CITY of NOVI CITY COUNCIL

Agenda Item G
January 7, 2013

SUBJECT: Approval of a request from Great Oaks Landscape Associates, Inc. for a variance from Section 11-239(b)(1) of the Design and Construction Standards requiring all parking areas, including parking spaces and maneuvering lanes, to be hard-curbed to allow the installation of an uncurbed commercial driveway. The applicant has demonstrated that enforcement of the standard cross-section would result in a substantial hardship in conducting landscape business operations on this site.

**SUBJECT: Great Oaks Landscape Driveway Plan, JSP12-0059,
Traffic Review of Preliminary and Final Site Plan**

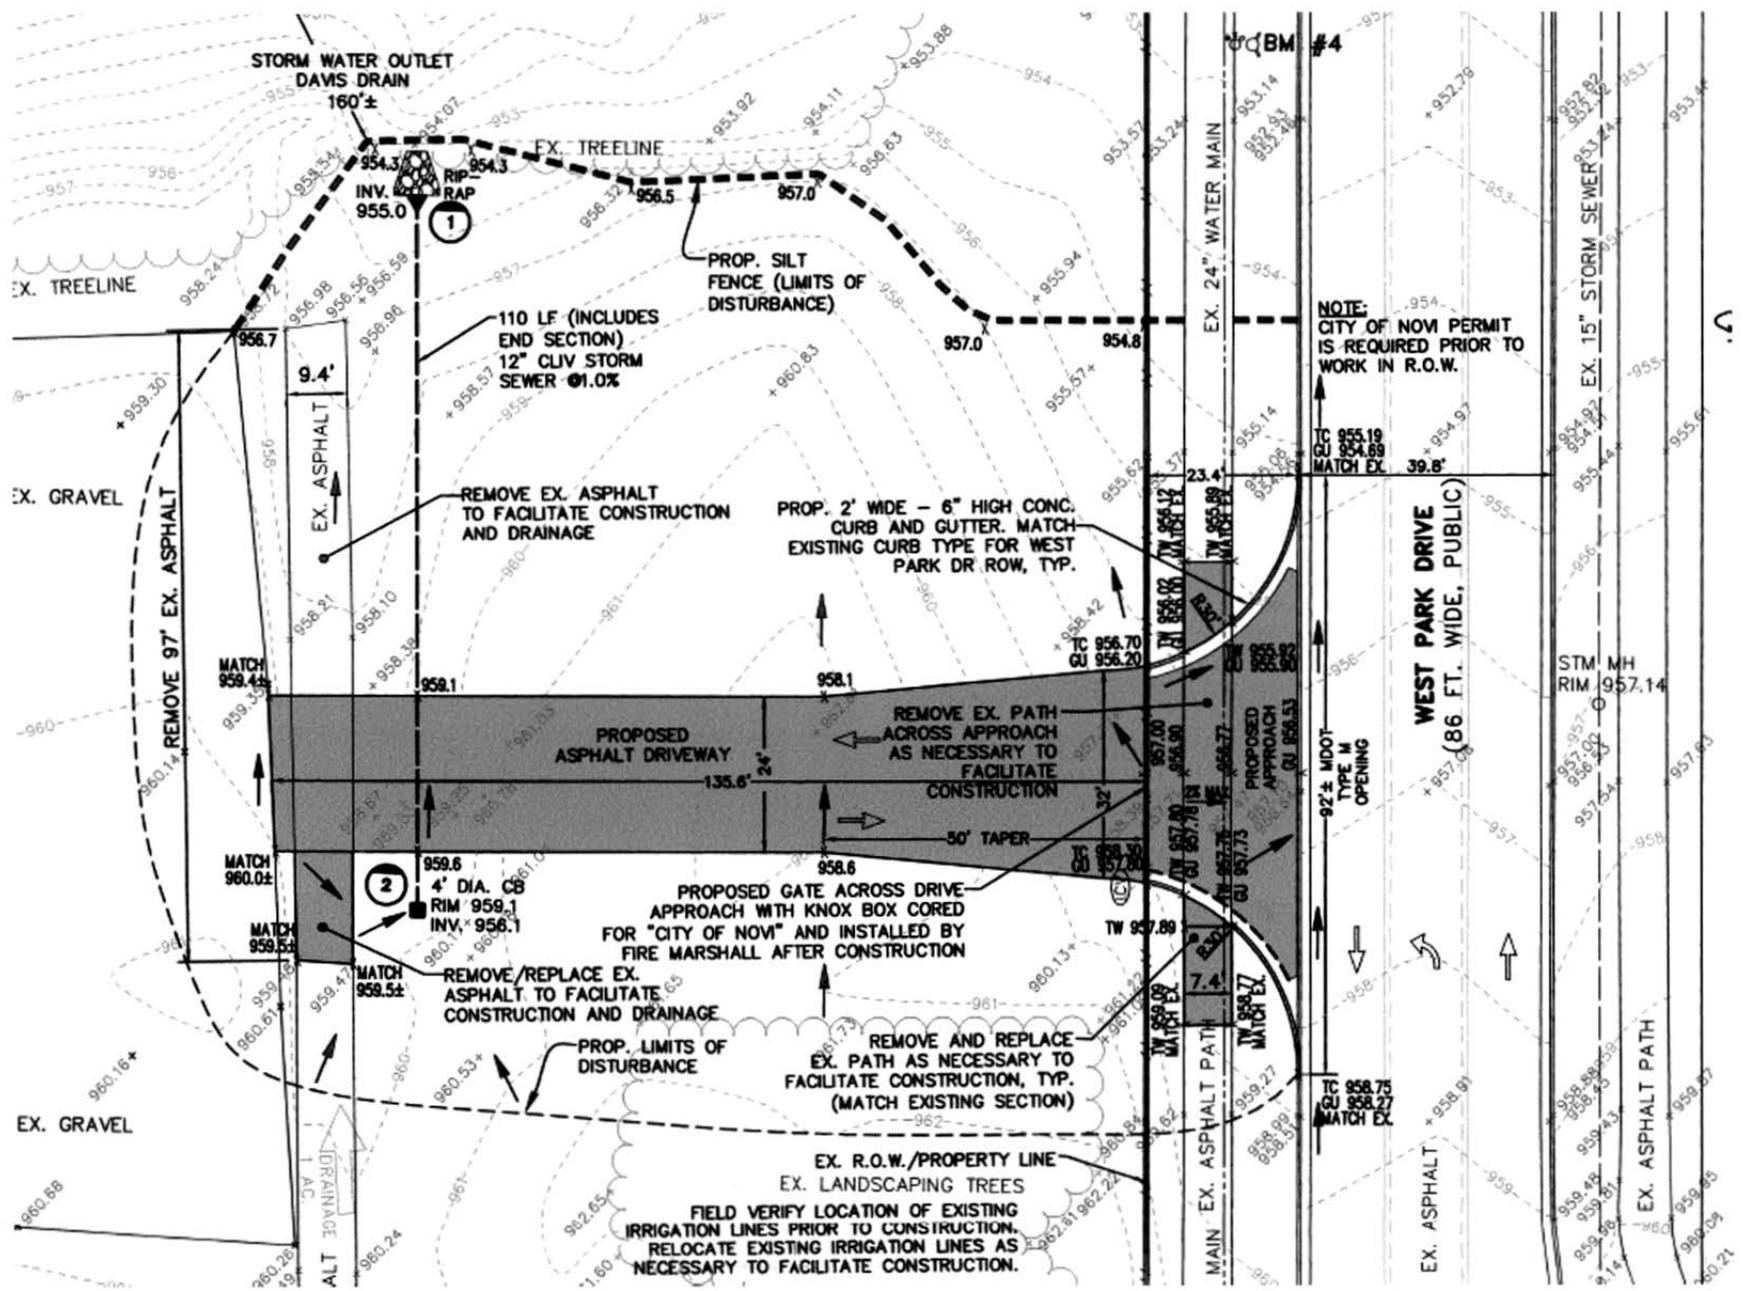
4. Although it is clear that the proposed driveway location also satisfies City standards for same-side driveway spacing, the plan incorrectly dimensions the spacing to the north; **that spacing should be shown from back of near (tangent) curb to back of near (tangent) curb; per Google Earth, it appears that the same-side driveway spacing to the north would be about 396 ft, not close to 1,001 ft (as now dimensioned, out of scale, between the points of tangency of the curb returns).**

8. If this were simply an emergency access drive, we would have no problem with locating the proposed gate at the right-of-way line as proposed. However, any other type of driveway use, no matter how infrequent, would result in an entering truck obstructing the south-bound travel lane of West Park Drive if the driver had to stop to open the gate; this would not provide a reasonable level of traffic safety. **It is essential that the gate be left open whenever routine (non-emergency) driveway use will occur; if this can not be assured (and indicated on the plan with an appropriate note), the gate should be relocated further into the site, at a distance greater than the longest truck or truck-trailer expected to enter here (preferably 75 ft minimum), and the driveway should be paved from West Park to at least the gate. A City Council waiver of the paving requirement will still be required west of the gate.**

9. **Consistent with the intent of DCS Figure VIII-K, 12-inch x 12-inch red reflectorized diamond panels should be installed back-to-back on the proposed gate. A detail of that gate must be included on the final site plan.**

10. **Sight distance triangles consistent with DCS Figure VIII-E should be added to the plan. Given multilane West Park Drive and its 45-mph speed limit, the long leg of each triangle should be 510 ft long.**
